618 JOHN STREET

SDCI PROJECT 3038245-LU

DESIGN REVIEW BOARD | RECOMMENDATION MEETING SEPTEMBER 07, 2022

CLOUD VS MOUNTAIN MATERIAL CONCEPT

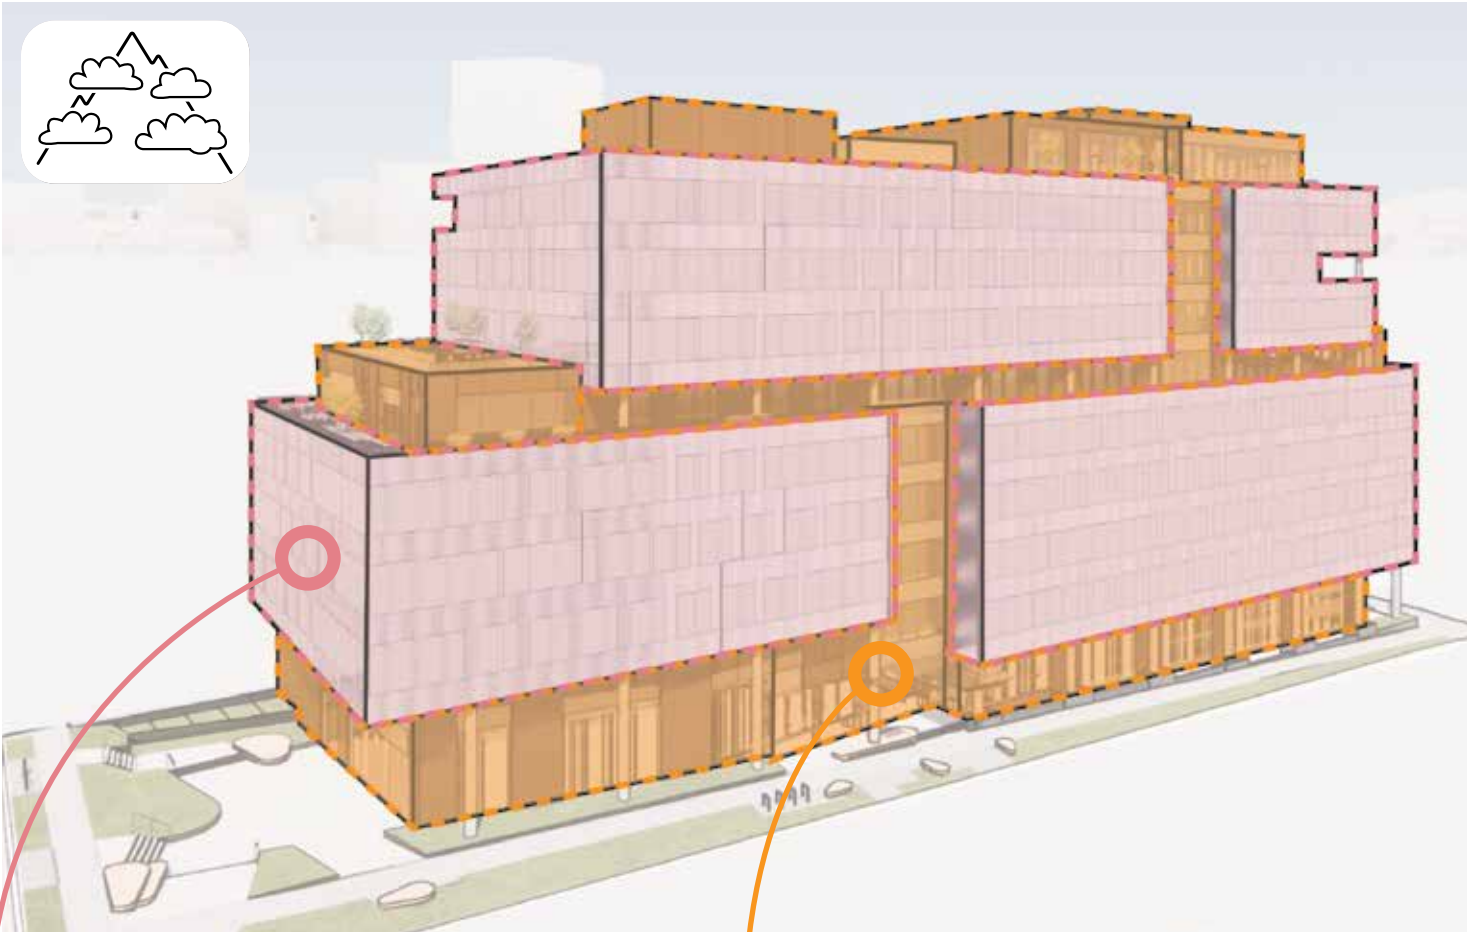
1a - The Board supported the concept of the “sticky space” recess around all sides of the building. However, they were concerned the proposed depth (3.5 feet in the presentation, 5 feet shown in the packet) was not yet providing enough distinction between the volumes and recess, resulting in a rather flat facade from certain views. As such, the Board directed the design team to increase the depth of the “sticky space” with the goal of strengthening the architectural concept. The Board clarified the increase in depth should be carried around all sides of the building, however, acknowledged the proximity of the mechanical core along the west alley façade would somewhat dictate how much setback could be gained along this side. Though there may be some variation in setbacks, the overall expression should support a harmonious articulation of this design around all sides of the building. The Board noted resolution of the sticky space setbacks would be required prior to their support for any related façade modulation departures. (CS2-C-3 full block, uptown DC2 Architectural Concept, DC2-5 Tall Buildings)

The evolution of the design has clarified the form and materiality of the building facade. We are looking to natural systems to inform the design and root it in its place.

The primary facade volumes are light and ephemeral, reflecting the character of the clouds and sky. The remaining zones, also known as sticky space, will be rich and tactile, reflecting the character of earth.

This interplay of cloud elements, and mountain elements will wrap around all sides of the building. The eastern facade, with more space around it, will be lighter and more ephemeral, like clouds floating in front of a mountain. The west, more constrained by current and future neighbors, will be more solid with sparser cloud-like forms. The north and south both have multiple terrace zone, like mountain overlooks.

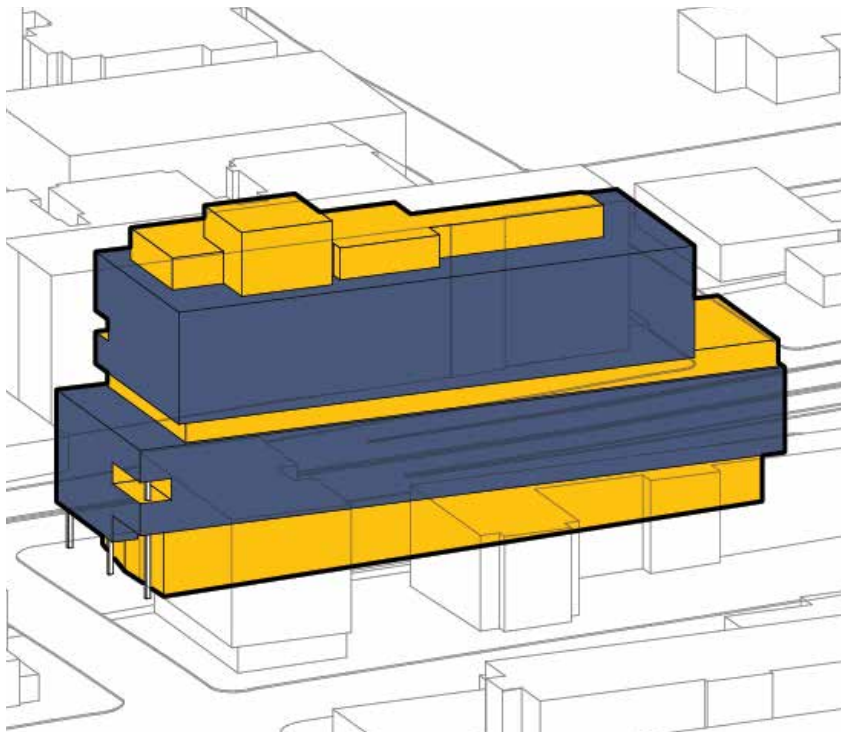
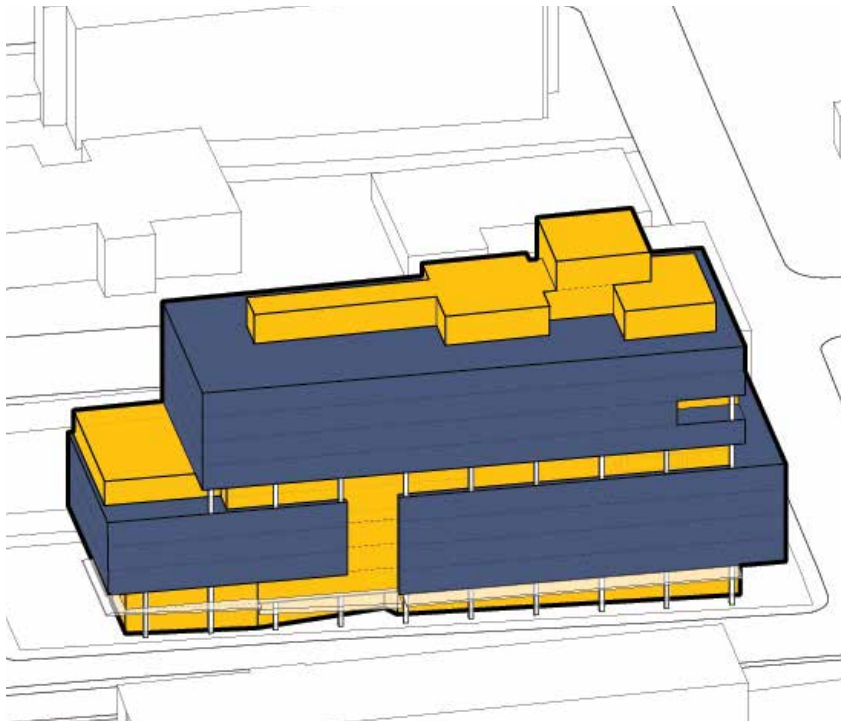
1b - The Board expanded on the setback conversation, noting there could be some massing refinement to the 3 cubic volumes as well, possibly growing the volumes in certain areas, while creating more substantial recesses within the sticky space. (CS2-C-3 full block, uptown DC2 Architectural Concept, DC2-5 Tall Buildings)

To clarify the massing parti, the inset zones have been enhanced where occupied space can be realized. These deeper recesses are balanced with bumped out areas at the north and south creating two level cascading terraces. These differences in plane are further amplified by changes in materiality.

This strategy has enhanced the building design while also creating inviting and usable outdoor spaces for the tenants.

STICKY SPACE - HORIZONTAL

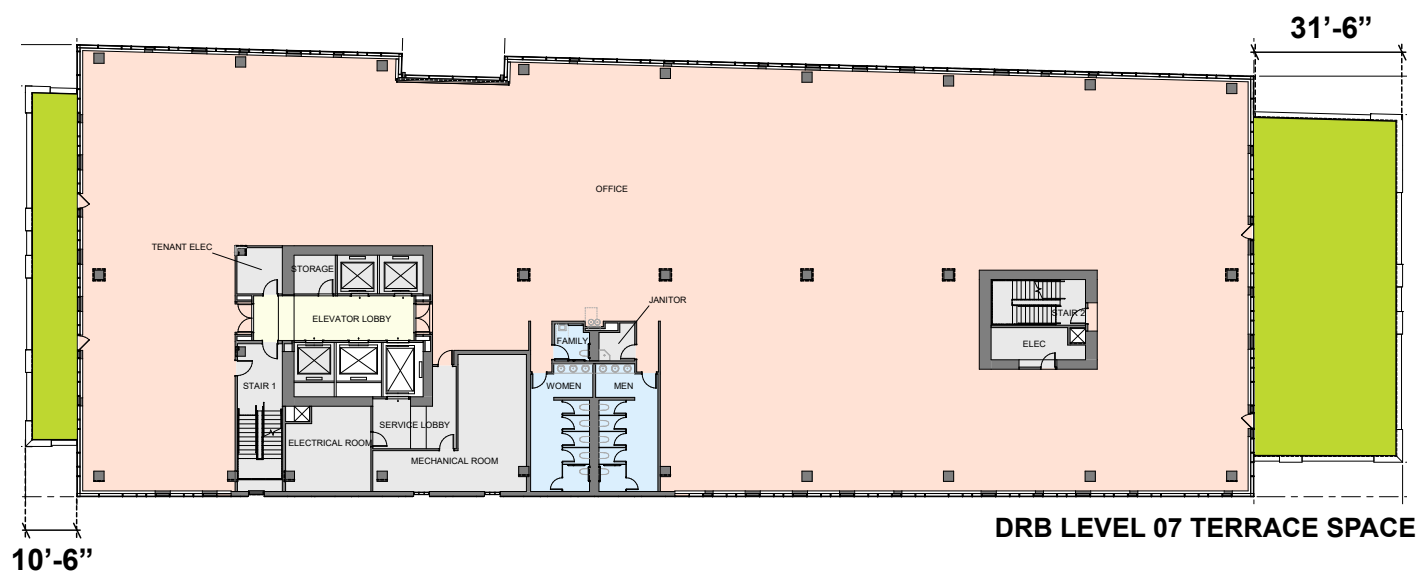
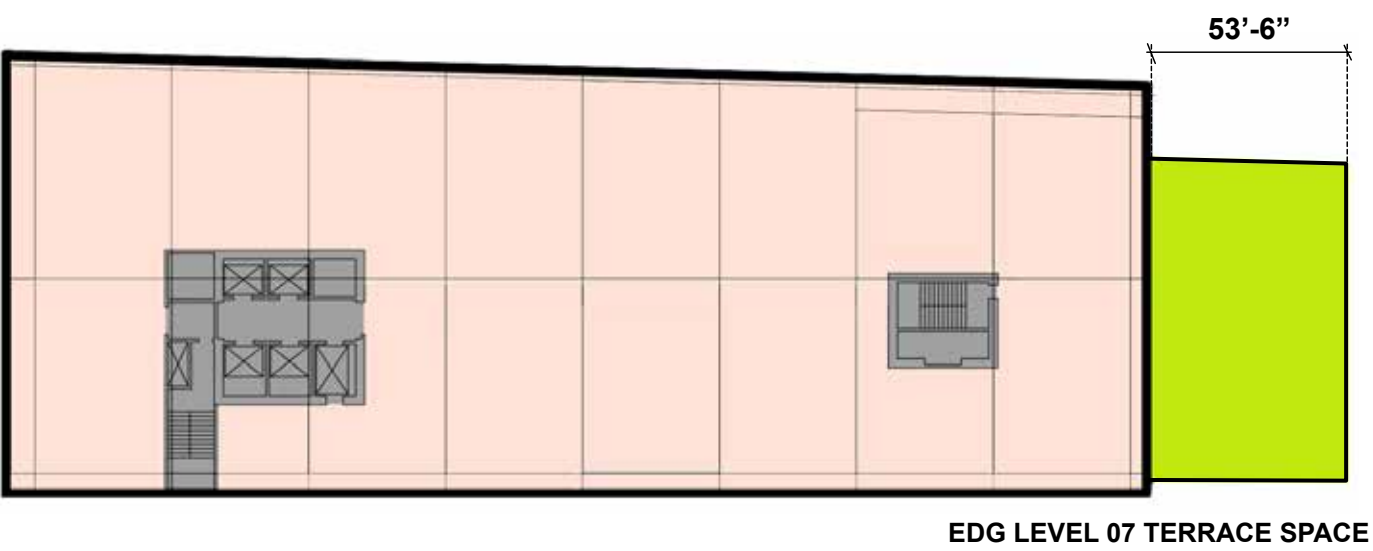
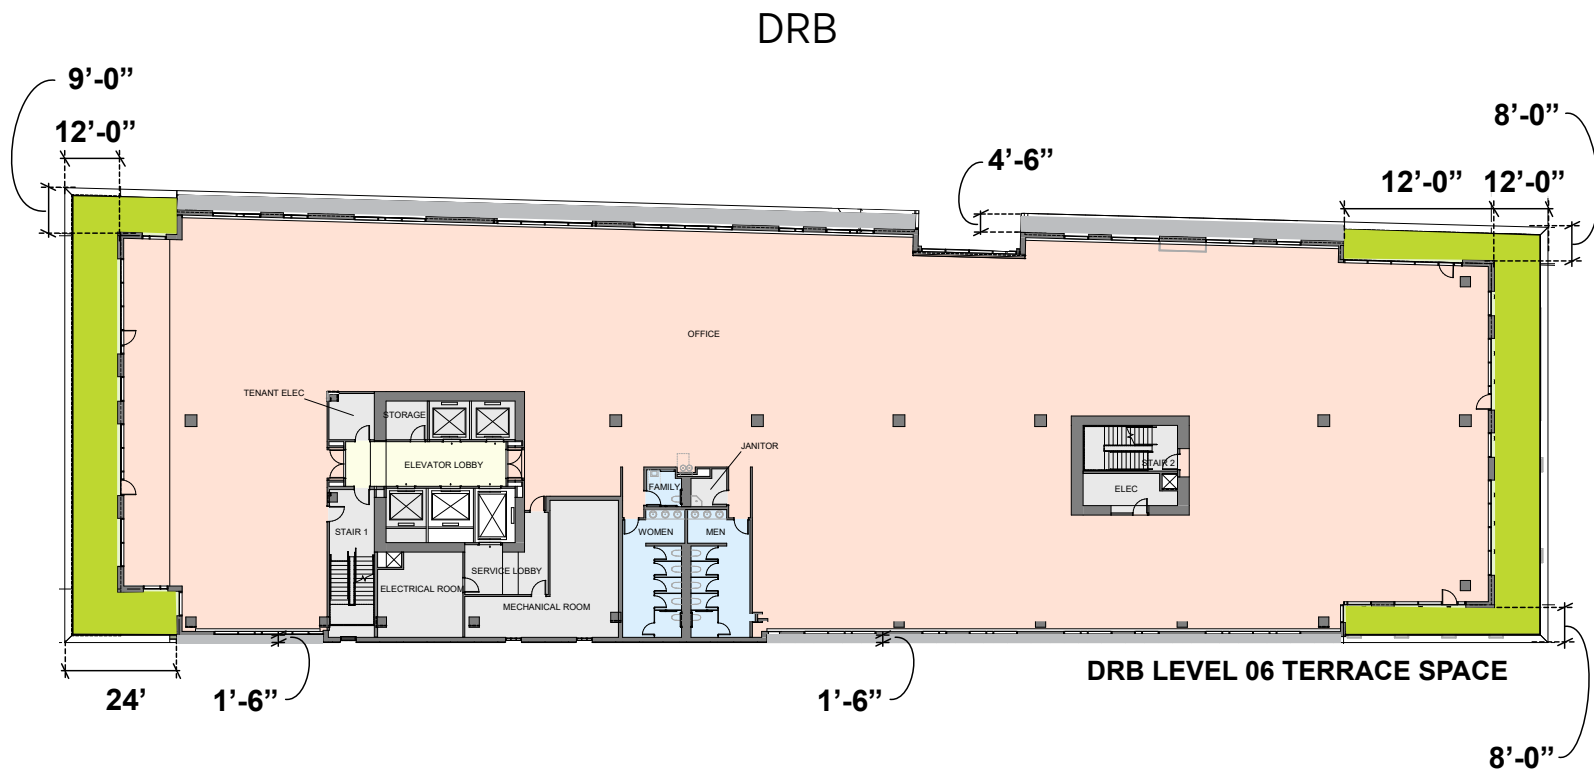
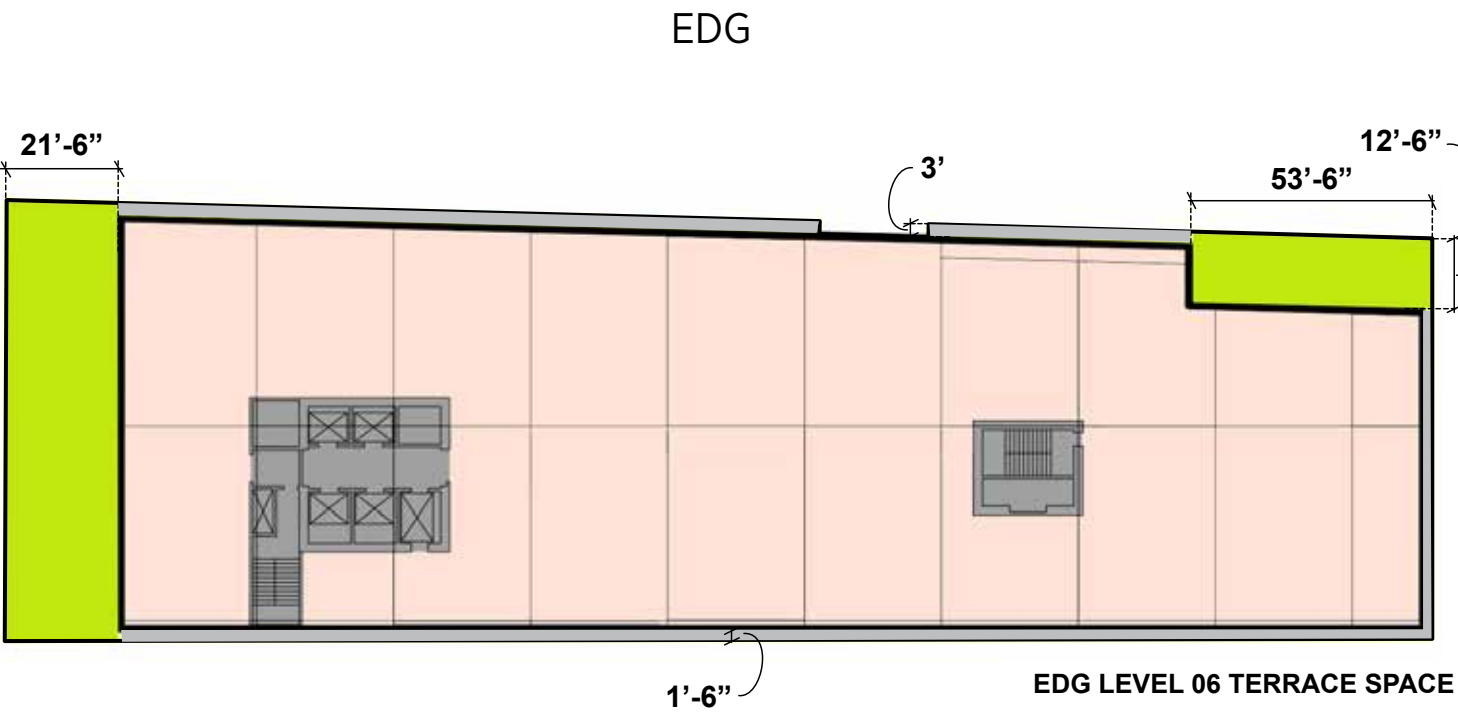
1c - Related to increasing the sticky space setback, the Board encouraged creating occupiable moments within the sticky space terraces, to again further strengthen the architectural concept. The Board noted this could benefit the project by further animating the spaces above street-level. (CS2-C-3 full block, uptown DC2 Architectural Concept, DC2-5 Tall Buildings)

The design of the “sticky space” has been optimized to focus more depth where it can be best activated by occupant use. Floorplate and terrace testfits informed these positions.

These occupiable zones at Level 6, focused at the southern extent of the 7th Avenue facade are increased to 8’ deep. This dimension will allow for a variety of configurations for these terrace zones.

The terrace space wraps the building creating occupiable space at the north and south and even turns the corner along the Alley.

While the “sticky space” is recessed at the east and west, at the north and south it is steps out, creating a two level, cascading terrace zone.

The terraces were deepened or otherwise enhanced everywhere that we determined would be usable and activated by occupants. The remaining areas were left with shallower recess to maintain a rational structure, clear constructability, and sound weatherproofing.

STICKY SPACE MATERIALITY (BROWN BRICK AND DARK MTLP)

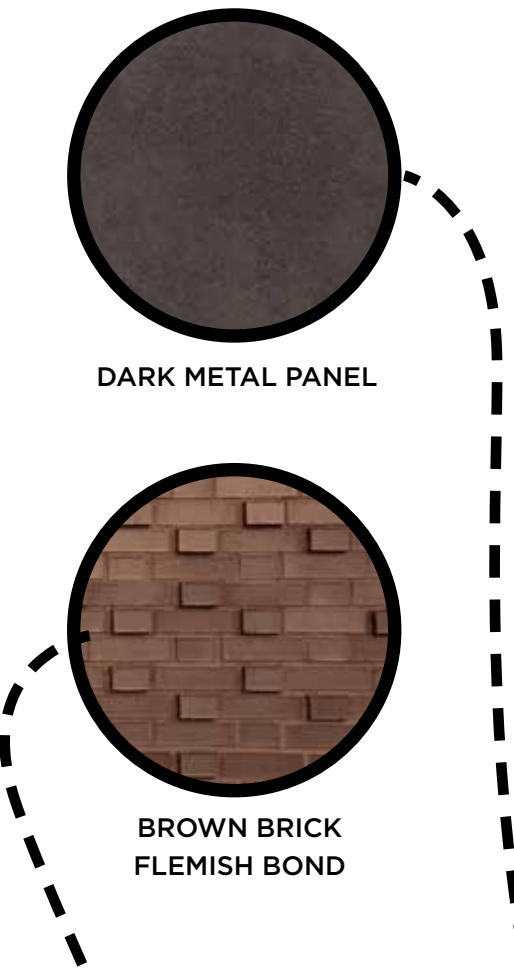
1d - The Board gave direction to refine the expression of the sticky space at the south 6th floor terrace to bring this area into harmony with how the sticky space language is happening around the building. The Board noted the sticky space at this location projected out, in contrast with the recessed language elsewhere on the building. The Board noted this could potentially be resolved by aligning the recess of this volume with the first floor, material treatment, or a combination of revised recess and material treatment. (DC2-B-1. Façade Composition)

The design of the Level 6 terrace space has been revisited, along with “sticky space” throughout the building. At both the north and south the “sticky space” projects out creating a double terrace condition at levels 6 & 7. At the east and west, stick spaces recess in, allowing for occupancy where appropriate.

The terraces will feel like an extension of rich landscape at the ground. The brick material being used at the base will also be used at the Level 6 terraces and the rooftop. The synthesis between the formal and material expression create a consistent story from bottom to top.

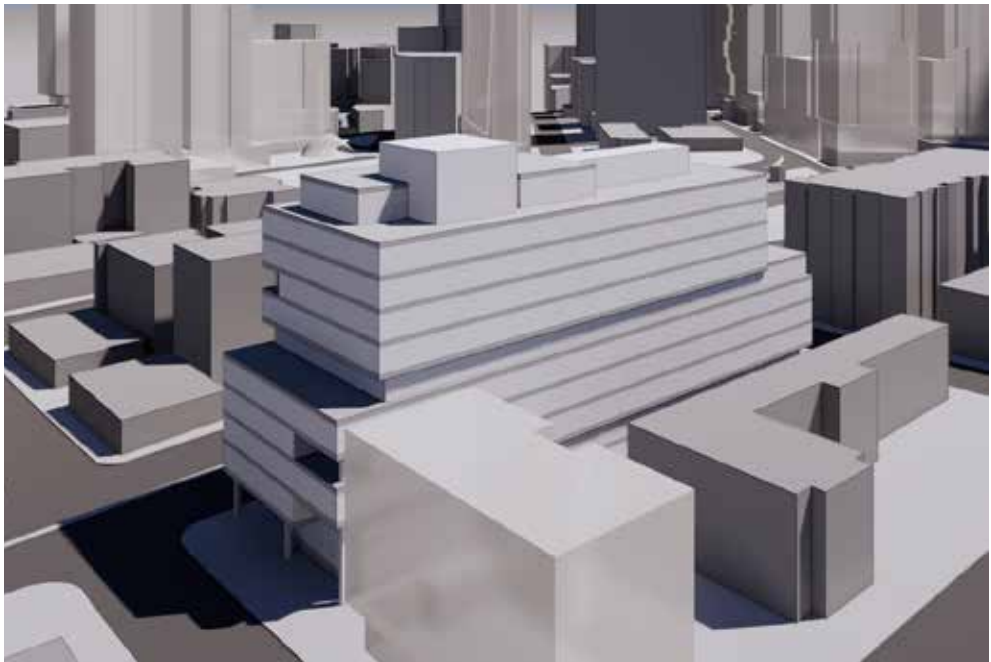
1e - The Board emphasized support for the 4-sided design language and noted this should be maintained moving forward. (CS2-C-3 full block, uptown DC2 Architectural Concept, DC2-5 Tall Buildings)

The proposed design maintains the four sided design shown at EDG. The design is cohesive and consistent on all four sides, but evolves to reflect the different frontages.

The east glassy and light, with small bands of materially rich more solid facade breaking it up. The north and the south both have significant setbacks with terrace zones that are extensions of the ground plane. The west, facing the alley has relatively less glazing, and relatively more solid, patterned facade representing the mountainous environs. Those solid zones are concentrated at the base, and fall off at the building meets the sky.

At the base, a consistent rhythm unifies all 4 sides, with brick giving way to a CMU block with similar color and texture at the west.

FLOW OF GROUND FLOOR

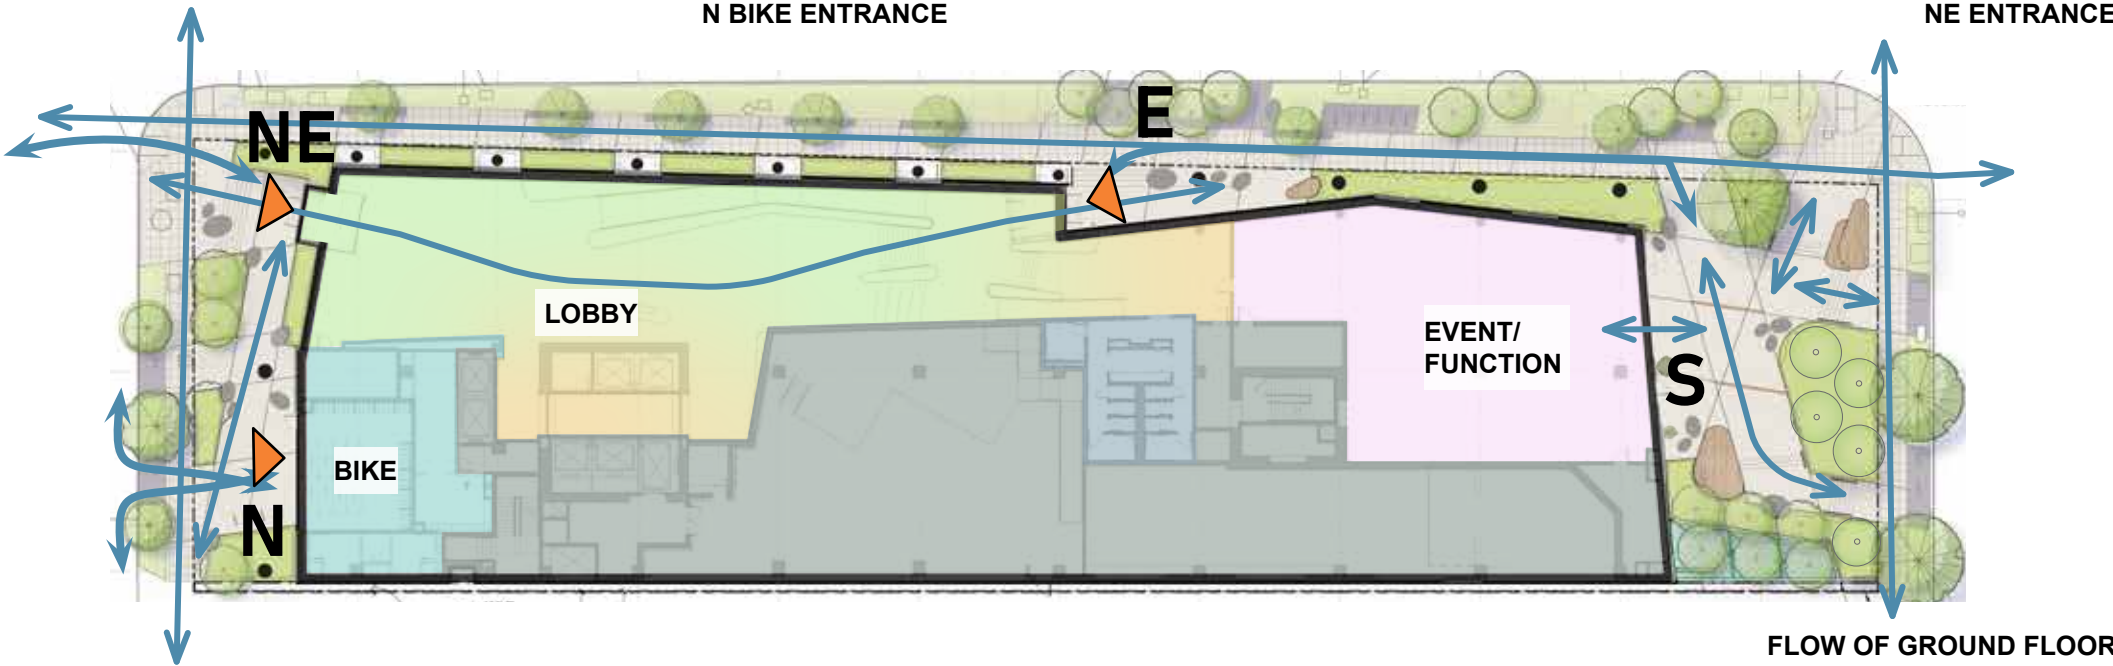
2a - Further consideration of entries and overall porosity around all 3 arrival points (Thomas Street, John Street, and 7th Avenue). As a full block site, the Board noted the importance of considering how the programming and open space could work together to promote pedestrian movement around the site and activation. (uptown PL1 Connectivity, uptown PL3 Street-Level Interaction, PL4-A Entry Locations and Relationships, DC3 Open Space Concept)

The proposed design is encouraging more activation and movement around the site by providing building entrances or a public plaza at all three street facing frontages. There are two entrances into the main lobby. One on the north along Thomas Street and a second on the east near the center of the site along 7th Avenue. The main public plaza is on the south along John Street with a large sliding door for further interaction between interior/outdoor activities.
